MINUTE NO. 196

MODIFICATION OF THE ORIGINAL PLAN FOR THE
LOWER RIO GRANDE INTERNATIONAL FLOOD
CONTROL PROJECT.

JOINT REPORT OF THE PRINCIPAL ENGINEERS
RECOMMENDING MODIFICATION OF THE ORIGINAL PLAN FOR THE
LOWER RIO GRANDE INTERNATIONAL FLOOD CONTROL PROJECT

INTERNATIONAL BOUNDARY & WATER COMMISSION
 UNITED STATES & MEXICO
 LOWER RIO GRANDE FLOOD CONTROL PROJECT
 ANZALDUAS DIVERSION DAM
 LOCATION AND
 GENERAL PLAN

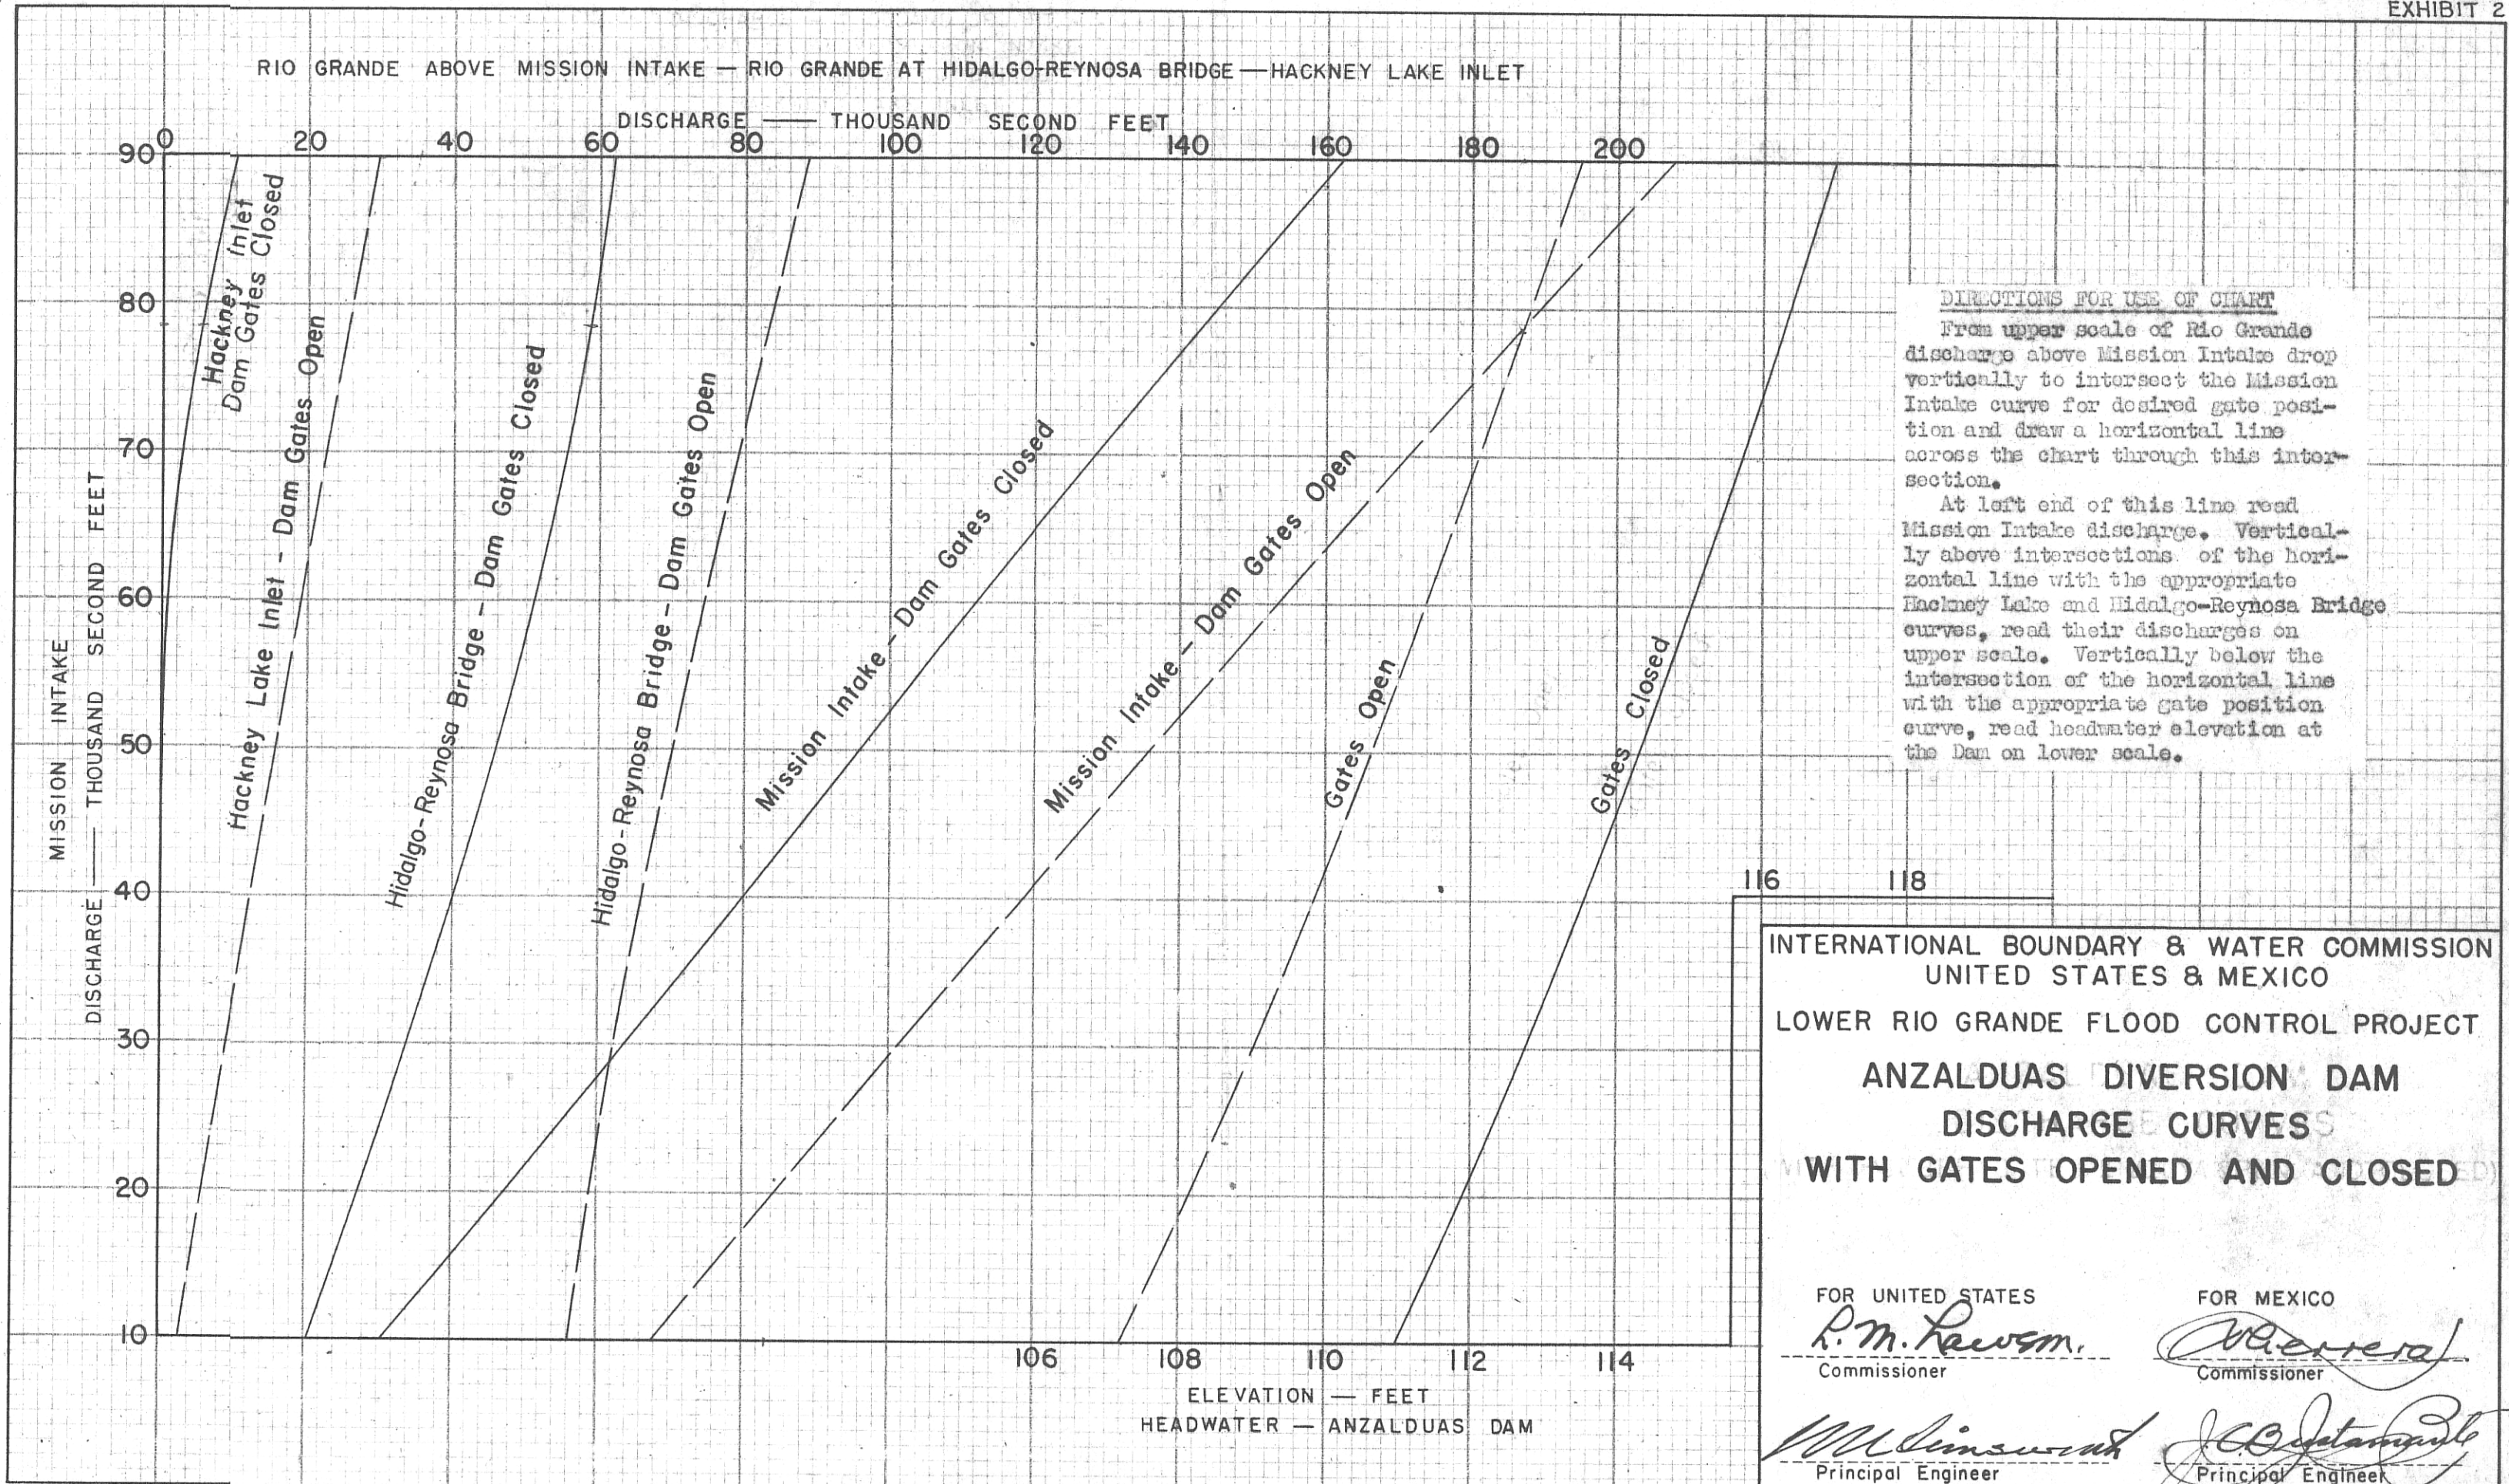
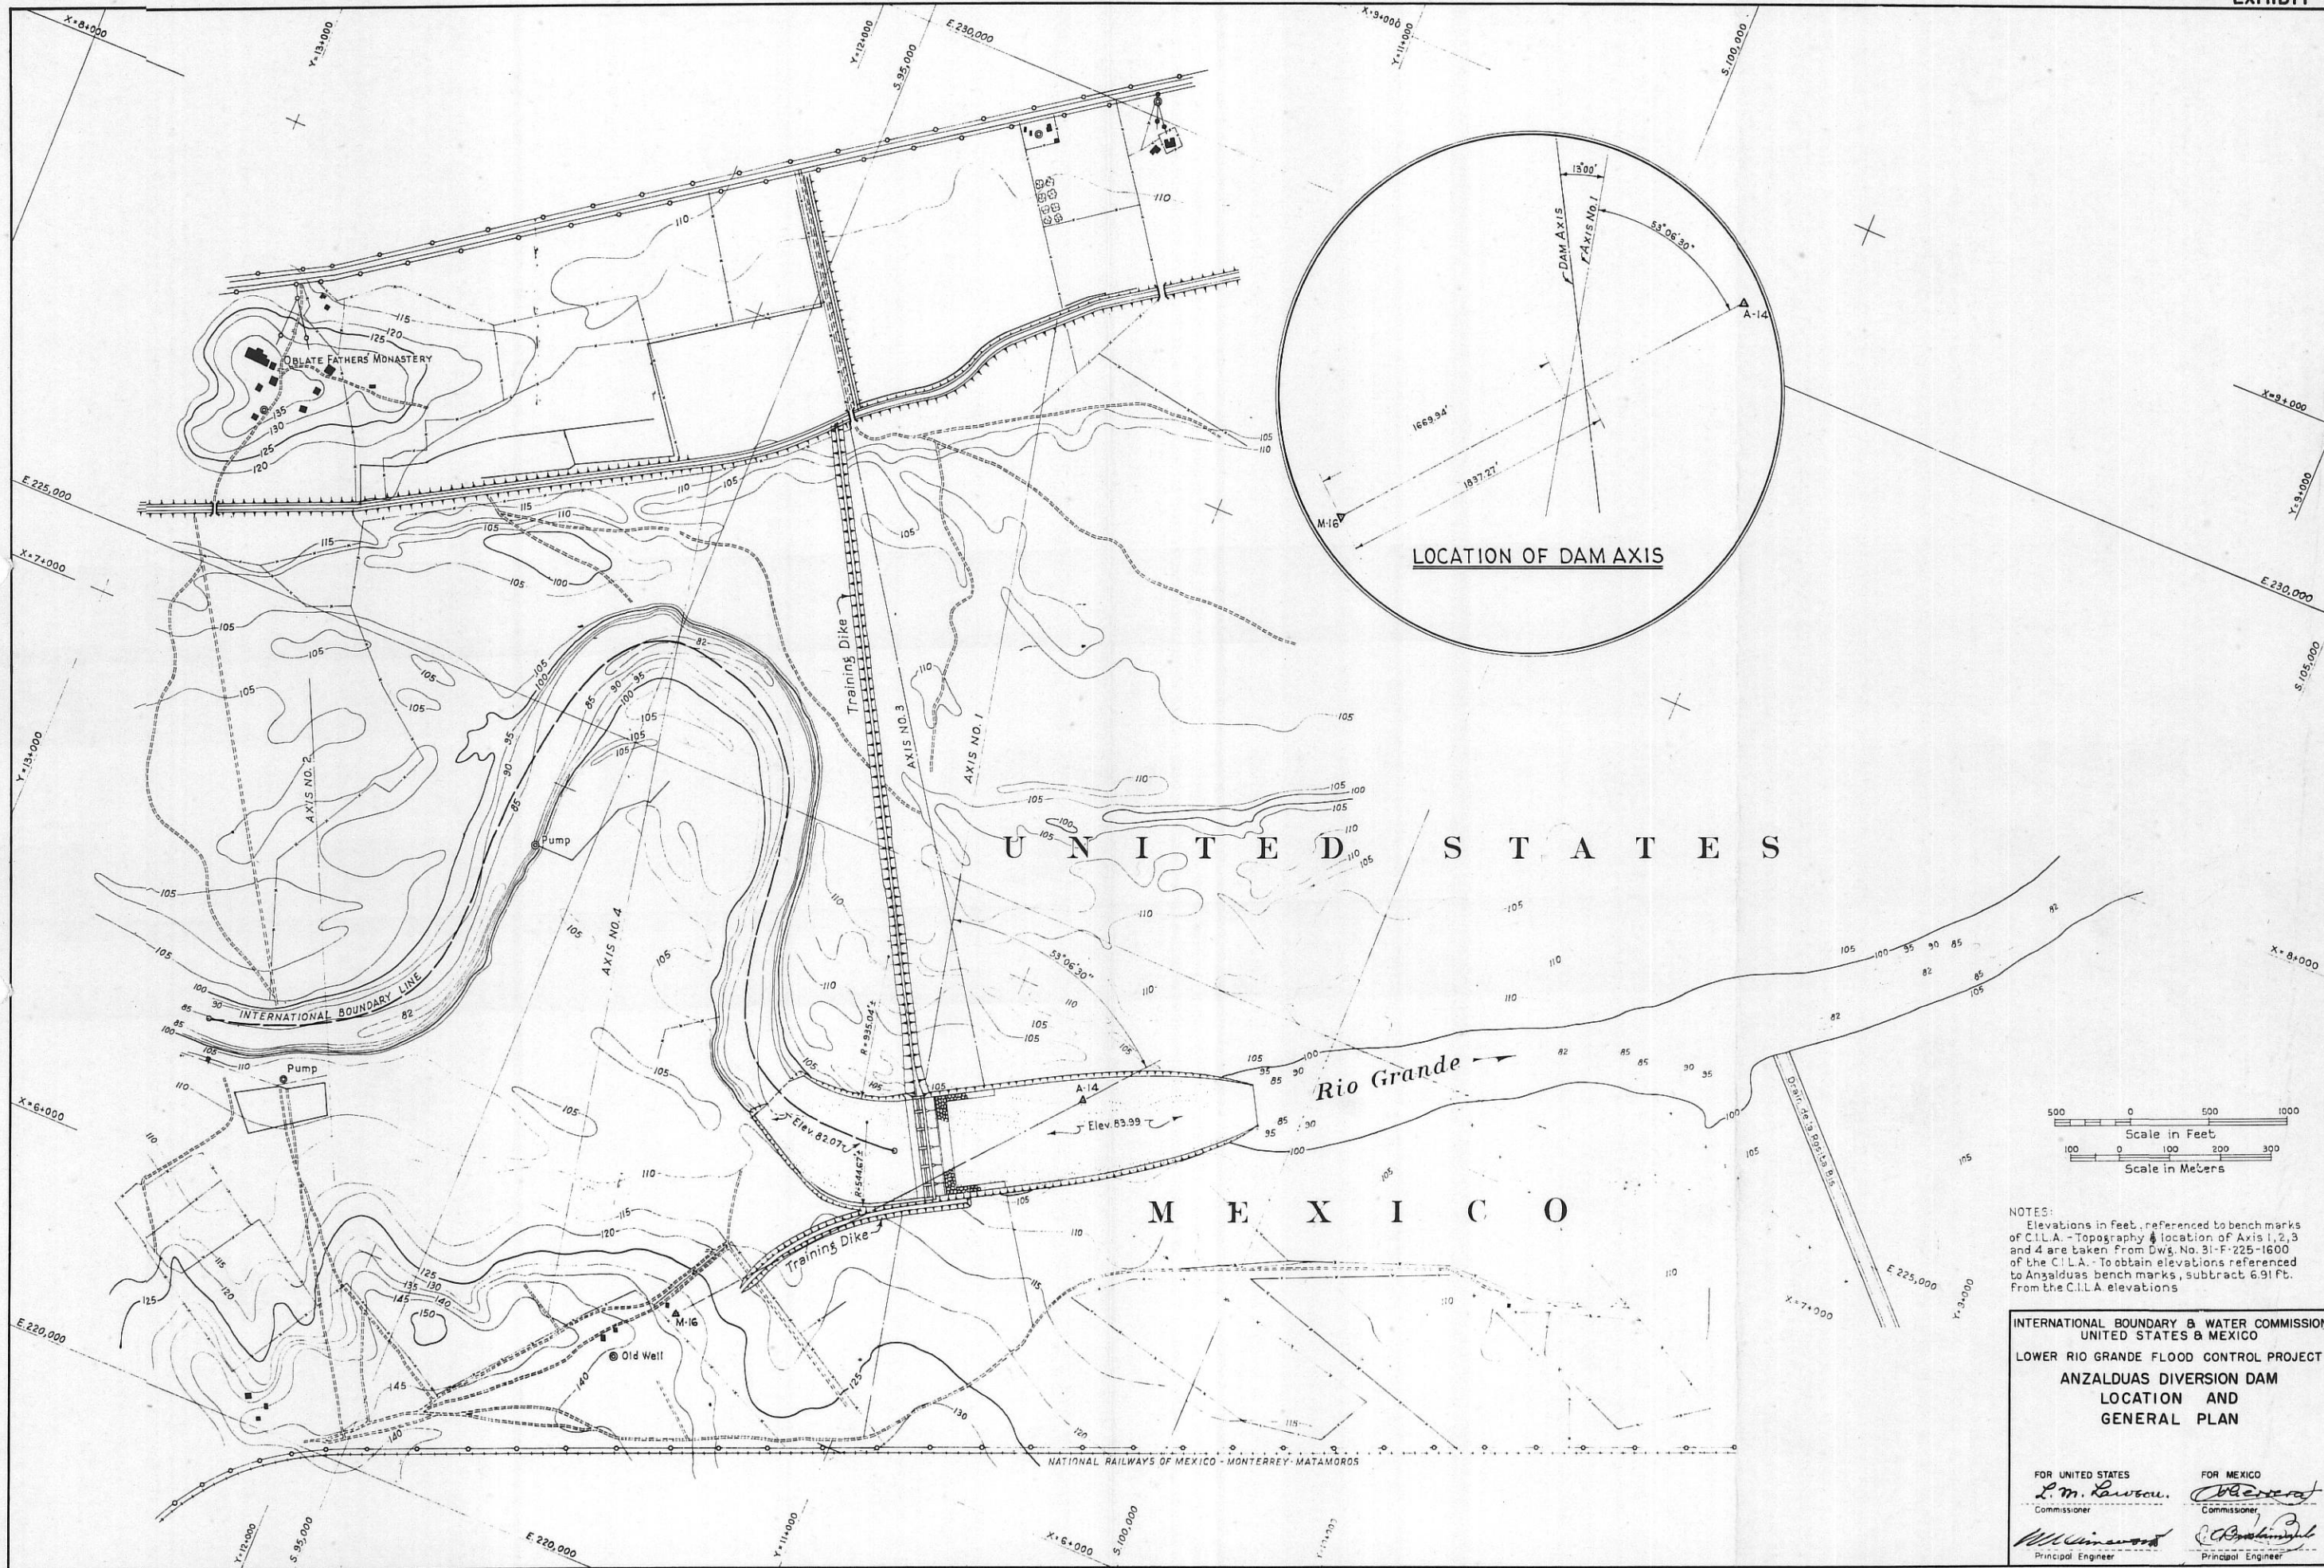
Several axis lines for the diversion dam in the Anzaldúas location have been investigated, and we have concluded that axis line No. 1, whose location is shown in Exhibit No. 3, "Anzaldúas Diversion Dam - Location and General Plan" hereto attached, should be adopted. Axis line No. 1 is situated approximately five miles above the Hidalgo-Reynosa Bridge. Foundation conditions have been investigated by means of core drillings which show that the dam will be founded on relatively hard sandstone.
